3 PROBLEMS AND RECOMMENDATIONS

**Proposed Access Strategy
 Roundabout off Chalkstone Way**

Appendix B – Amended Design Drawing for Access

FIGURE 462/3/4

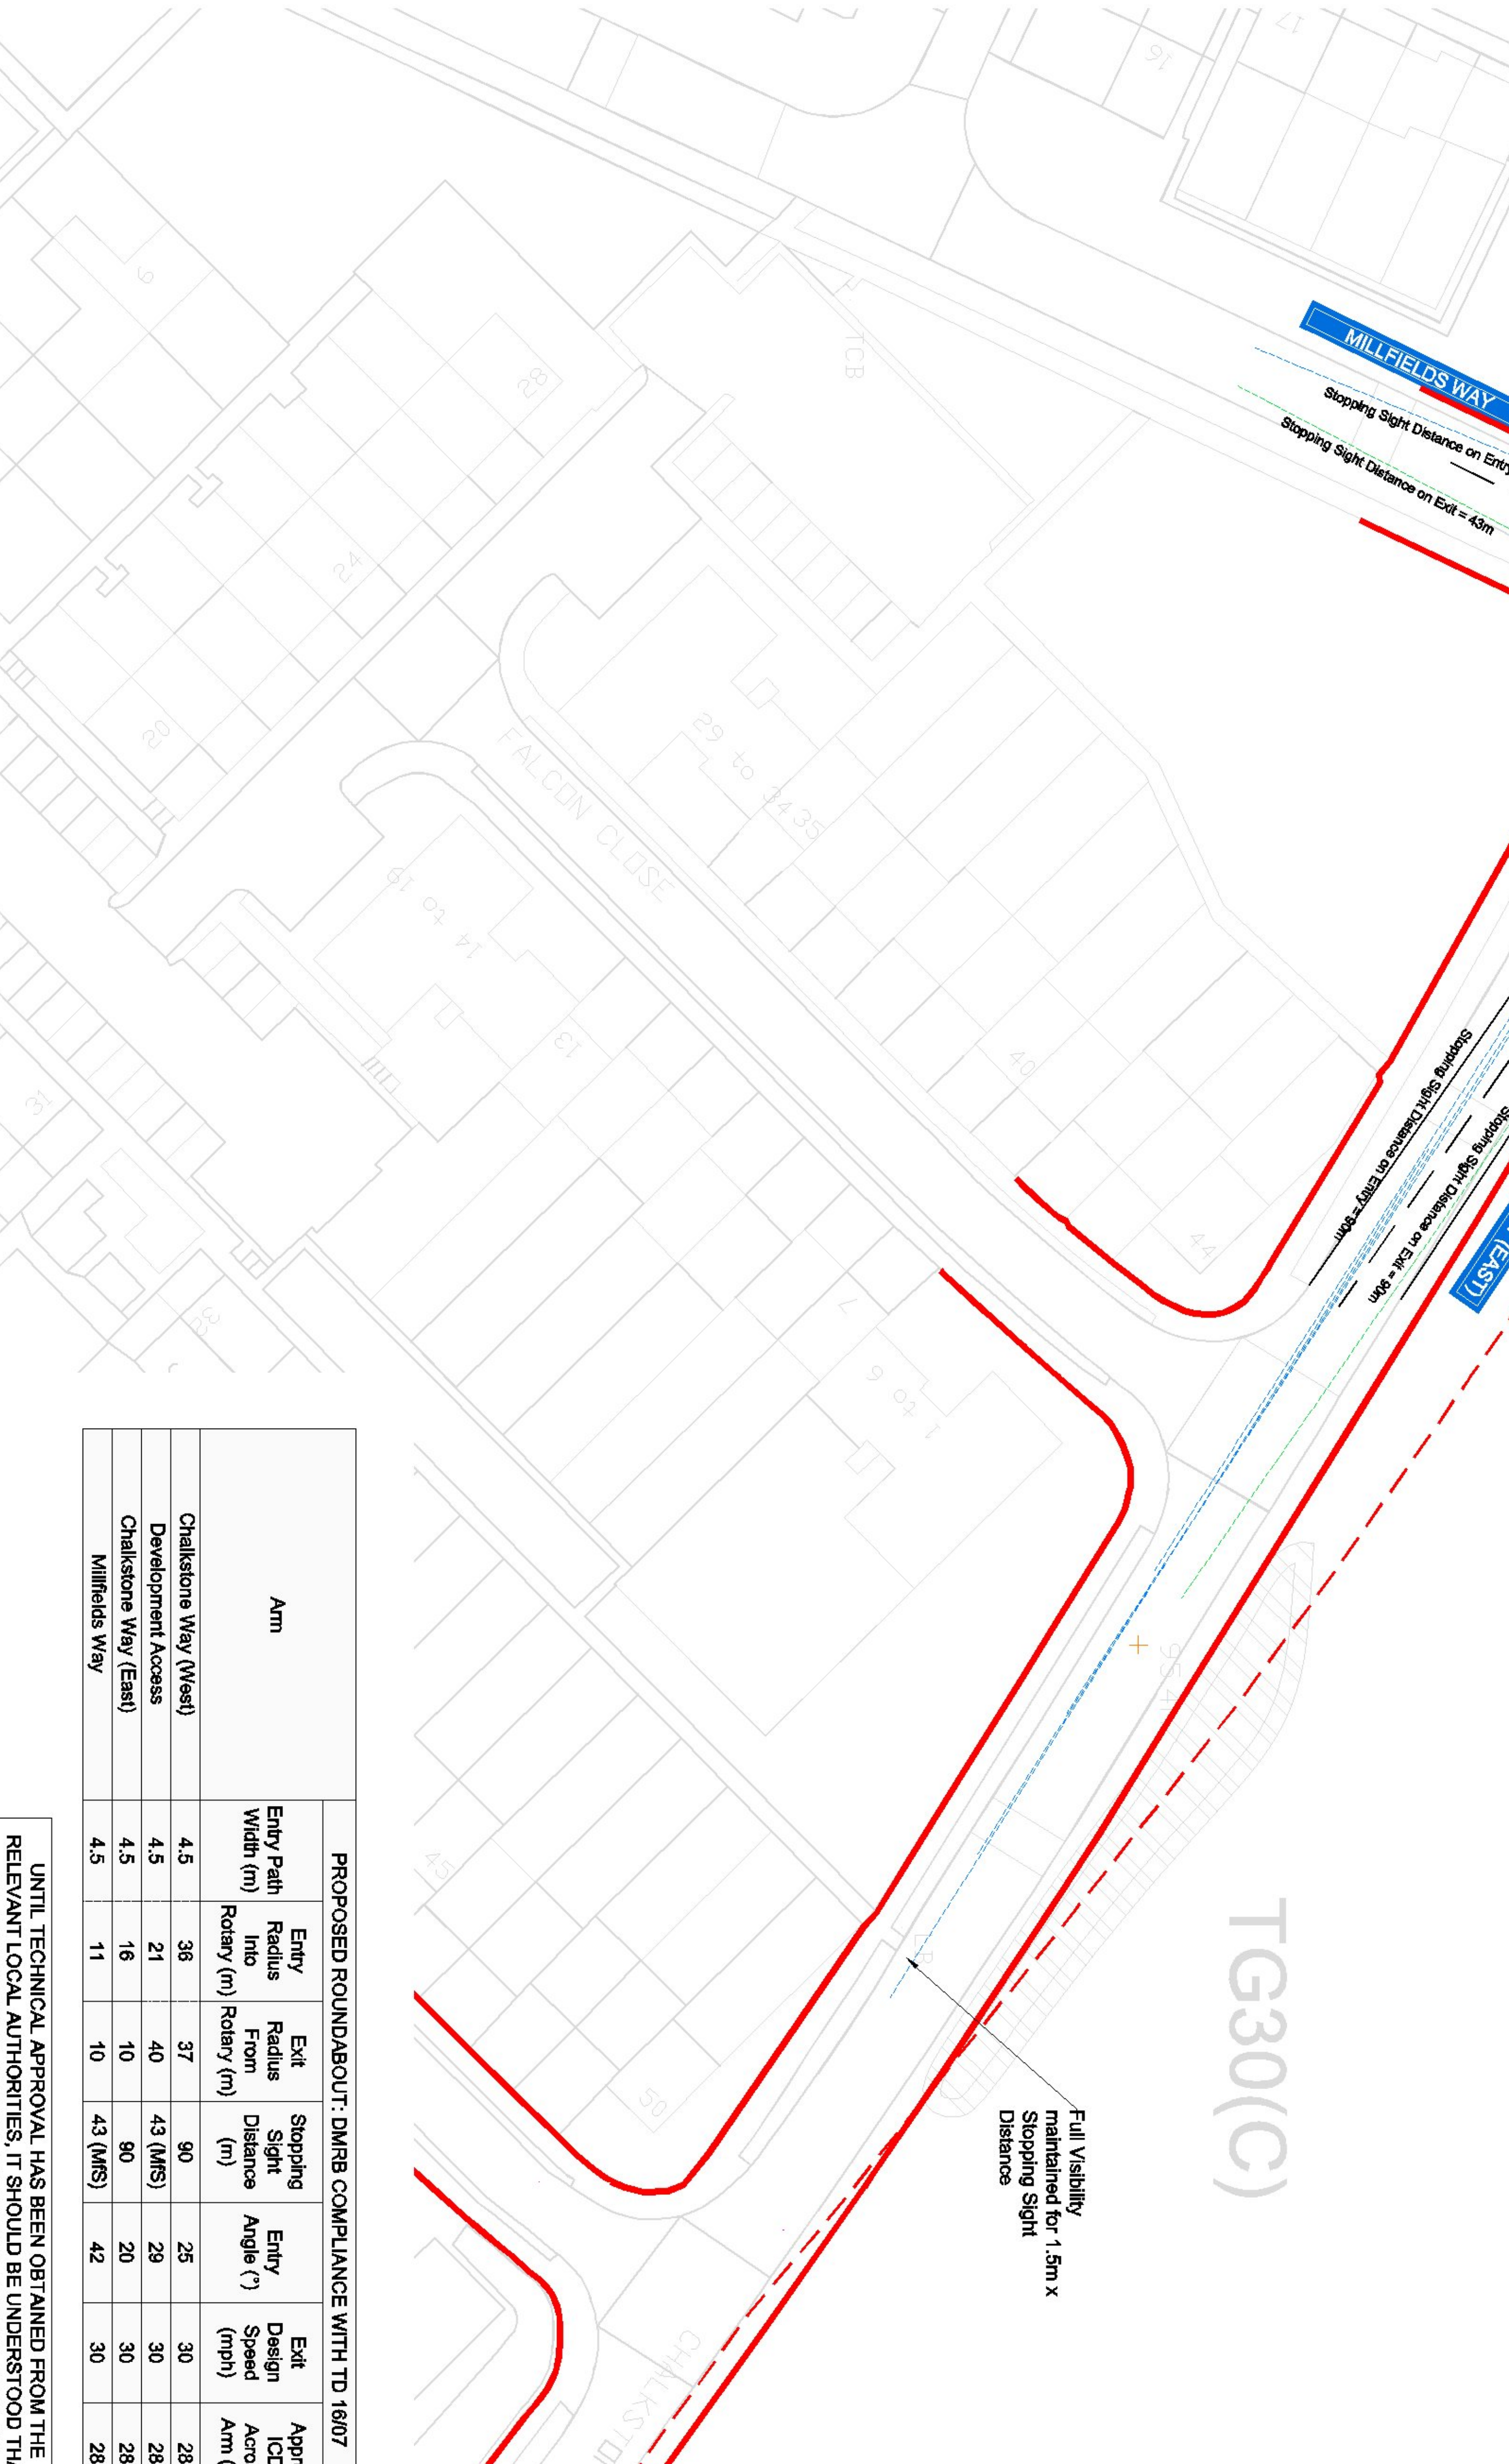
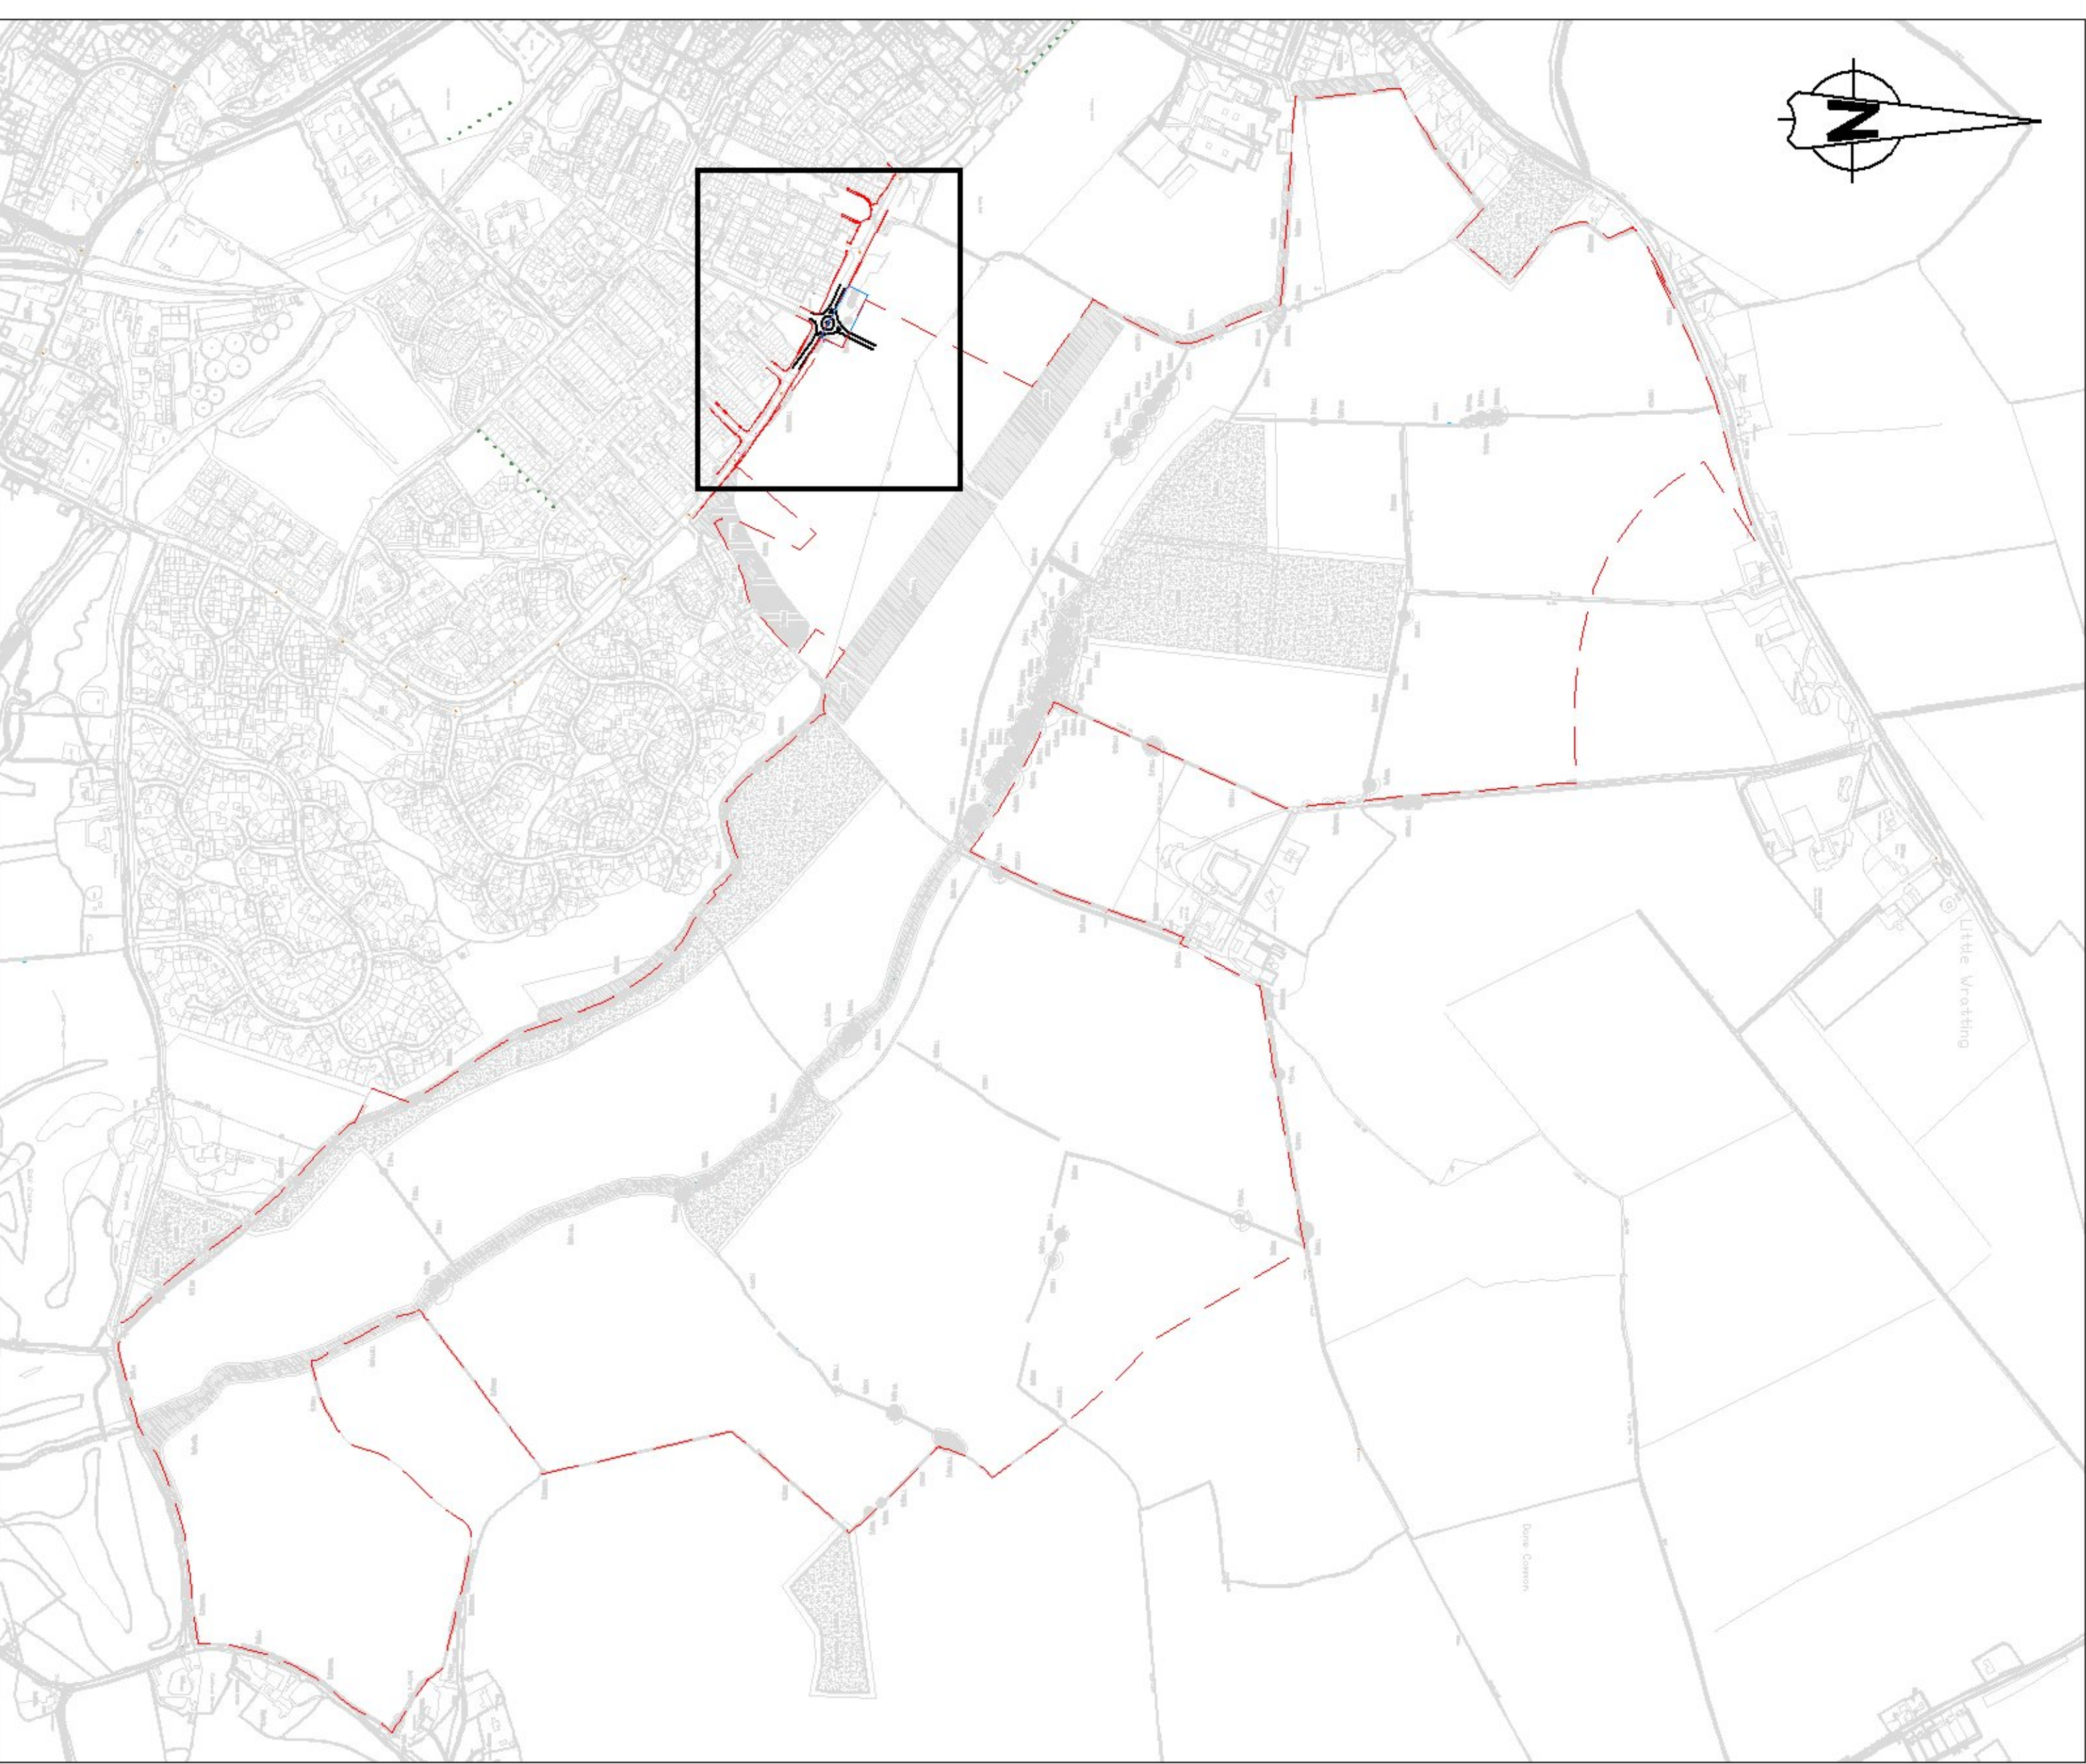
3.1 **Problem 1 : Inadequate deflection on vehicle paths**

Location: Eastern and northern arms approaches to the roundabout.

Summary: The design layout of the roundabout is such that there is potential for failure to give way on entry resulting in straight-ahead collisions with roadside furniture or side-impact or shunt type collisions.

- 3.1.1 For the roundabout entry from the east (Chalkstone Way) the entry path curvature is in the region of 140m and for the roundabout entry from the north the entry path curvature is in the region of 100m, both using the over-run area edge as the vehicle path guide. Such potential approach paths give inadequate entry path curvature to fully-prevent traffic from entering the roundabout at too high a speed or having to resort to late-braking (DMRB standard TD16 also refers).

- 3.1.2 The drawings do not show any traffic calming measures on the development Access Road.
- 3.1.3 Whilst the Auditors do acknowledge that Chalkstone Way is a traffic-calmed road the situation could be hazardous to cyclists, particularly in view of the wide overall circulatory carriageway width as associated with all compact roundabout layouts that are designed to accommodate specific large/long vehicle types, not all of which type might use the subject roundabout and approach roads.

3.2 **Problem 2 : NMUs**

Location: NMU paths to/from the development.

Summary: Inadequate provision of NMU facilities could lead to NMU conflicts and/or NMUs using non-designated routes or making crossings of roads at inadvisable locations with risks of slips, trips and falls injuries.

- 3.2.1 The footway from the development ends at the northwestern quadrant with pedestrians having to cross Chalkstone Way to gain access to the existing footway along the southern side of Chalkstone Way. Not far west of the proposed roundabout is the Westfield Primary Academy school so the Auditors would expect some NMU demand between the development (the Access Road roundabout) and the school which is not catered for in the current proposals unless such trips cross and re-cross Chalkstone Way.

3.3 **Problem 3 : Bus stop location**

Location: Chalkstone Way west of the roundabout.

Summary: Stationary buses blocking entry to the roundabout could cause risks of frustrated following vehicle drivers overtaking when unsighted and colliding with traffic exiting the roundabout or even driving the wrong way around the roundabout.

3.3.1 The existing bus stop west of the roundabout is located only approx. 25m ahead of the roundabout 'Give Way' line and the drawing has no indications of bus stop relocation.

3.4 **Problem 4 : Speed cushion feature**

Location: Chalkstone Way immediately west of the roundabout.

Summary: Proximity of feature to roundabout entry/exit would be a potential frustration to drivers causing potential rash decision-making or encourage pedestrians to cross the road where no formal crossings is intended and which could surprise drivers and lead to vehicle/pedestrian conflicts.

3.4.1 There is an existing speed cushion arrangement immediately west of the roundabout located only approx. 15m ahead of the roundabout 'Give Way' line and the drawing has no indications of its removal. With a roundabout so close the speed cushion arrangement would appear superfluous and could safely be removed – however, 'Problem 1' relates in respect of speed control on the roundabout approaches.

- 3.1.4 The recommendations are that :
- The roundabout should be re-designed to ensure that vehicle entry paths have radii tighter than 70m radius (such re-design might involve the provision of a larger roundabout) ; and

- Traffic calming should be applied to the development Access Road.

- 3.2.3 The recommendation is that :
- The footway along the western side of the development Access Road should be continued on to the school entrance not far west of the proposed roundabout with, perhaps, enhancement to shared cyclist/pedestrian status.

3.3.2 The recommendation is that :

- The bus stop should be relocated further west, sufficiently away from the roundabout.

- The speed cushion arrangement should be relocated a short distance further west.
